CERTIFICATE OF APPROPRIATENESS

**RE: Application Number 20-6981; 489 Henry; Cass-Henry Historic District
Project Scope: Rehabilitate Apartment Building**

RE: 489 Henry Street—The Berwin Apartments

Sheet
 1A402.1

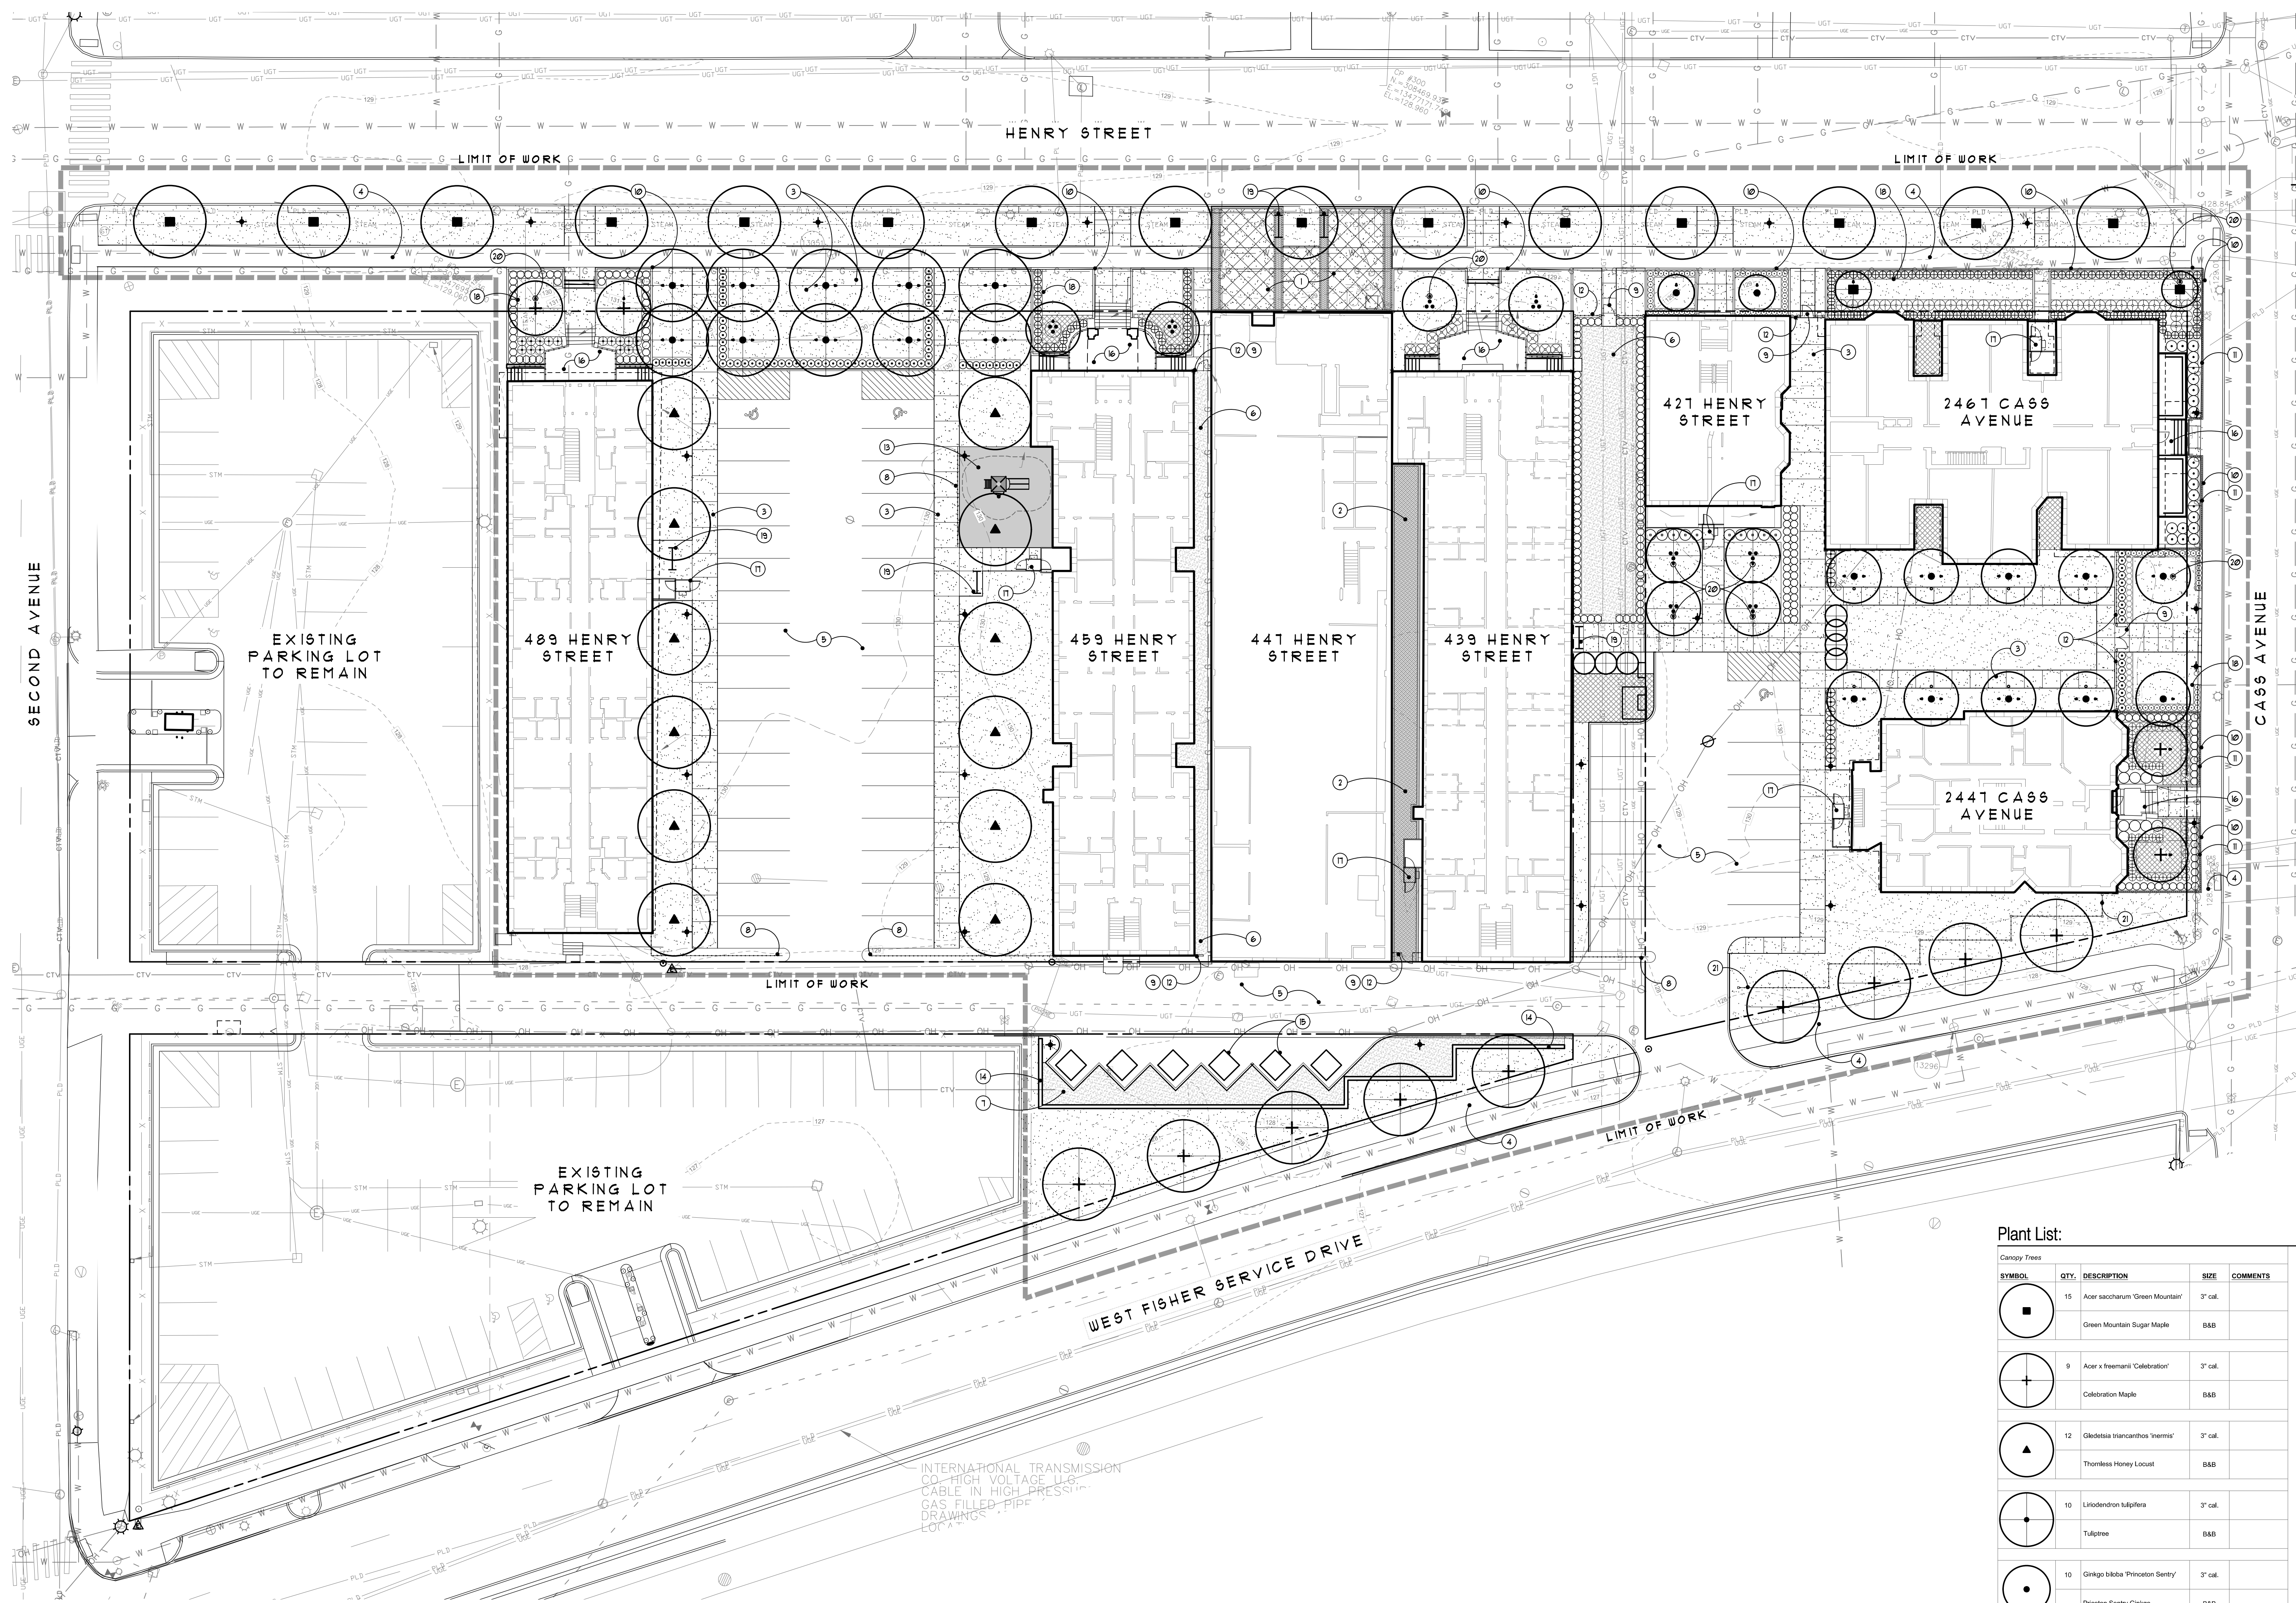
And as per the submitted documents, specifically, drawings 1A101, 1A102 (floor/roof plans) and 1A401, 1A401.1, 1A402, 1A402.1 (elevations).

- Staff review of the submitted construction drawings will include the identification of specific standards concerning repair and/or replacement of deteriorated character-defining features, and related standards concerning the qualifications of historic preservation contractors retained to perform the work.
- Staff review of the submitted construction drawings to specifically include review of specifications/cut sheets for lighting, windows, doors, ADA lifts, signage, paint removal, color choices, and other exterior elements/selections not yet finalized, with staff authority to approve if per the Secretary of the Interior's Standards, the district's Elements of Design, and otherwise consistent with Commission intent and guidelines.
- The historic name of the building, set in stone above the entryway, be preserved and remain visible.
